Re: Planning application P/22/026/FUL at Pengarris, 2 Bay View, St Mary's

We are writing to object to the proposals at Pengarris, 2 Bay View (ref: P/22/026/FUL). Our key reasons for objecting are as below:

Figure 1 - Mark-up of applicant's proposed beach elevation showing 5 Little Porth and a person (1.75m) standing on the proposed deck. Additional drawing is shown in blue.

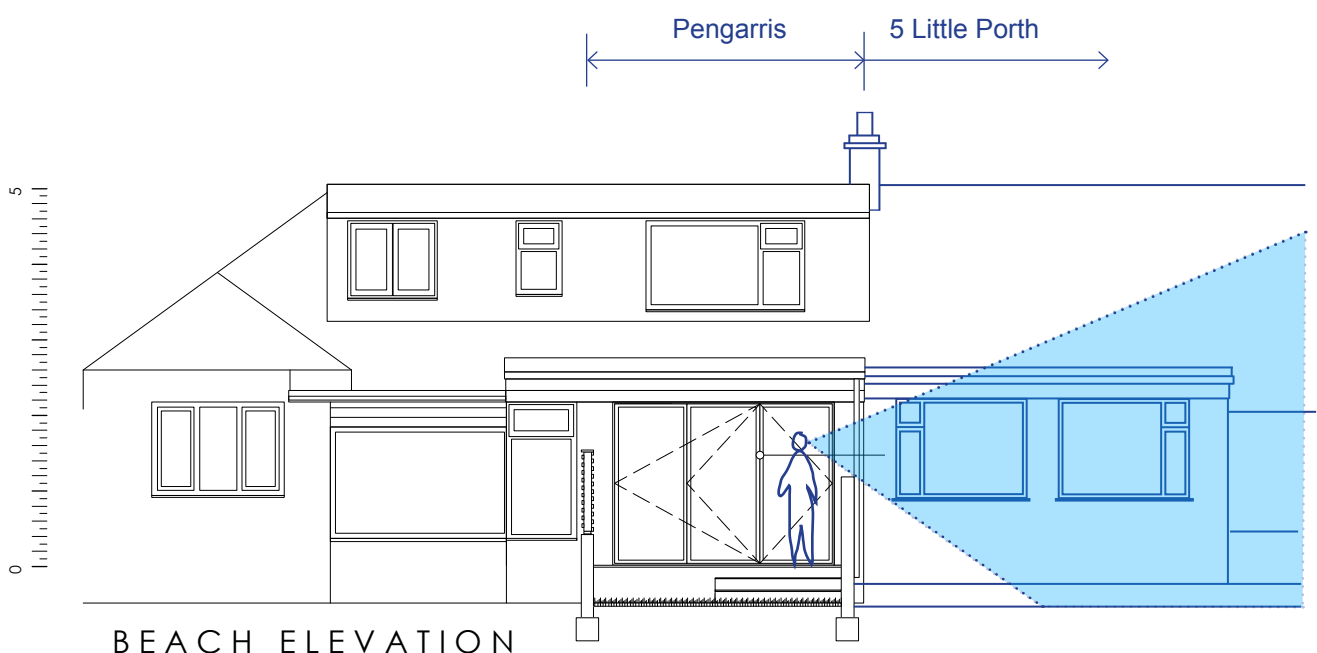
The proposed raised deck would cause significant overlooking and loss of privacy, due to the elevated nature of the deck above garden level. The applicant has not shown 5 Little Porth in any of their existing or proposed drawings. Please refer to Figures 1 and 2 below and overleaf, which show the adjoining rear elevation and plan of 5 Little Porth, and illustrate the extreme overlooking which would be caused by people on the proposed deck - particularly as the entrance door to/from Pengarris to the garden is proposed to remain on the side of the property adjacent to 5 Little Porth, so this part of the deck would be most frequented. The Isles of Scilly Design Guide states that "characteristics to avoid in new designs and alterations [include]: Bad neighbours [...] that overlook and dominate their surroundings and invade privacy".

Figure 5 - Mark-up of applicant's proposed elevation showing the correct existing wall height and position of existing adjacent windows in 5 Little Porth. Additional drawing is shown in blue.

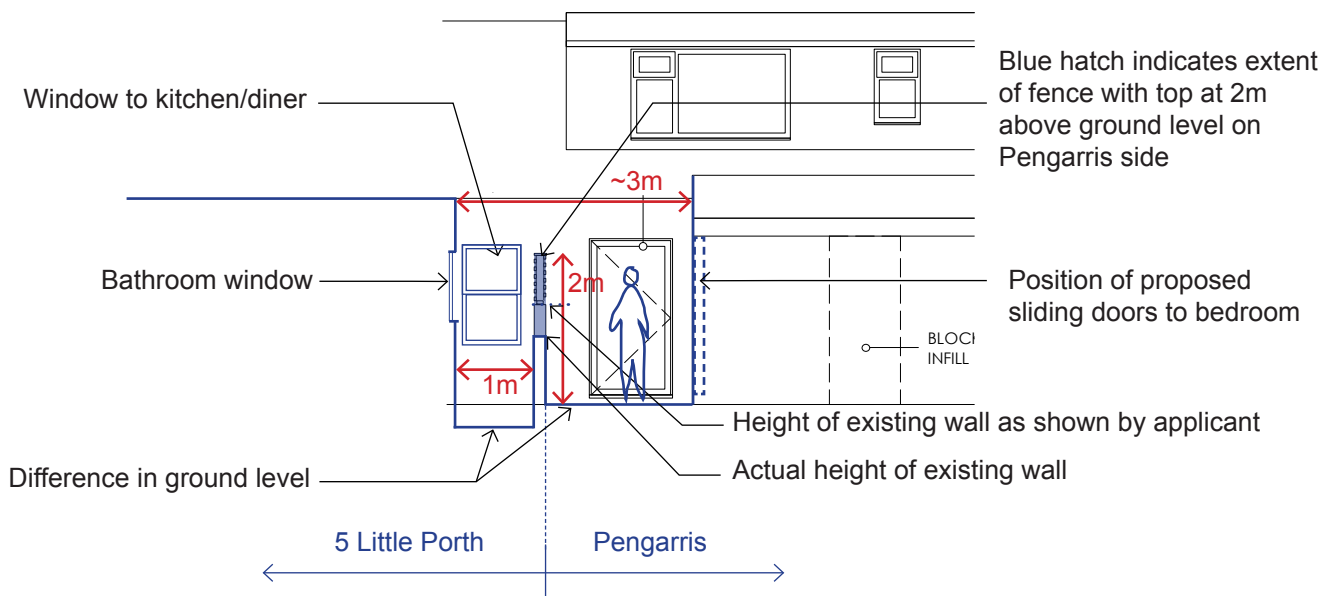
The proposed new boundary height at the road side of Pengarris would form a serious sunlight and daylight issue for 5 Little Porth. Once again the applicant has not drawn the context of 5 Little Porth in either their existing or proposed drawings. Please refer to Figures 5 and 6 below, which show the proposal in relation to 5 Little Porth, and particularly with regard to existing windows.

As can be seen from the drawings above, the proposed fence would block nearly all available sunlight and daylight to the already north-facing windows of the kitchen/diner and bathroom at 5 Little Porth. The proposed fence is also shown as being fixed to the top of the existing wall. This requires clarification, but we believe that the wall is in ownership of 5 Little Porth. Any consented elements would, therefore, need to be outside of the 5 Little Porth property boundary.

Figure 6 - Mark-up of applicant's proposed plan showing the position of existing adjacent windows in 5 Little Porth. Additional drawing is shown in blue.

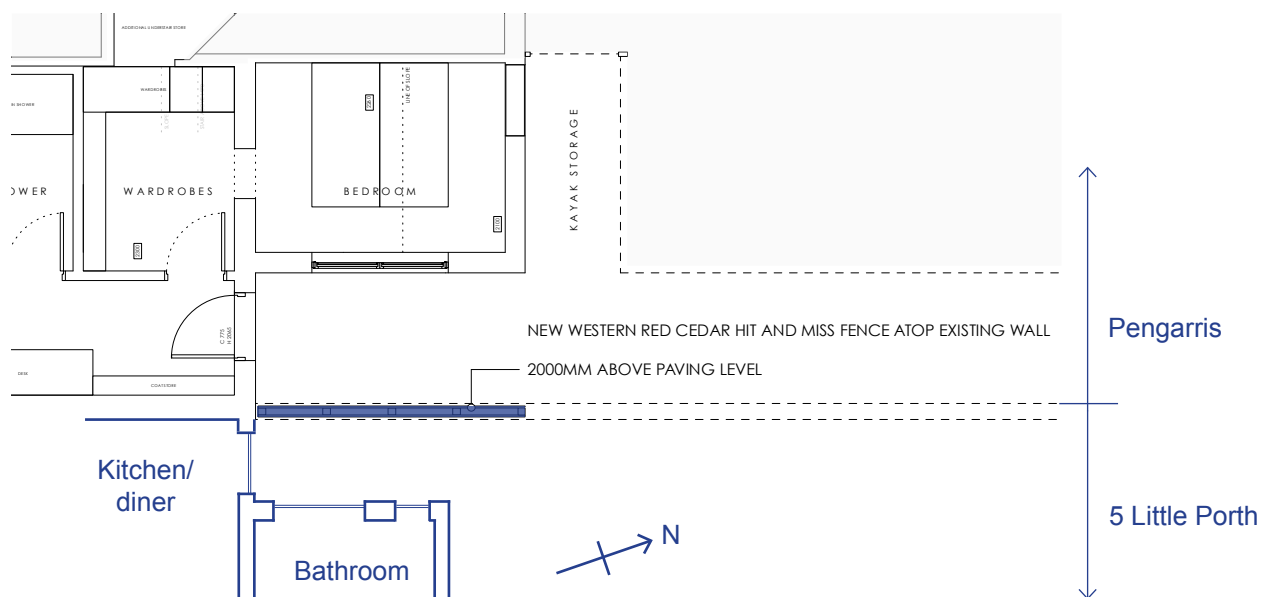
Without the fence, however - or if the fence were to be any lower - there would be serious privacy and overlooking issues. The kitchen/diner at 5 Little Porth is already partially overlooked by people approaching Pengarris along the path from the road. This proposal, however, with the proposed relocation of the front door and the proposed glazed sliding doors to the bedroom, would significantly increase this overlooking. While it is noted that adhering to the 21m rule between habitable rooms is not possible in this particular setting, the very short distance of 3m between facing walls/windows across the boundary wall is felt to be too tight to justify the proposed position of the full-height glazed doors to the bedroom.
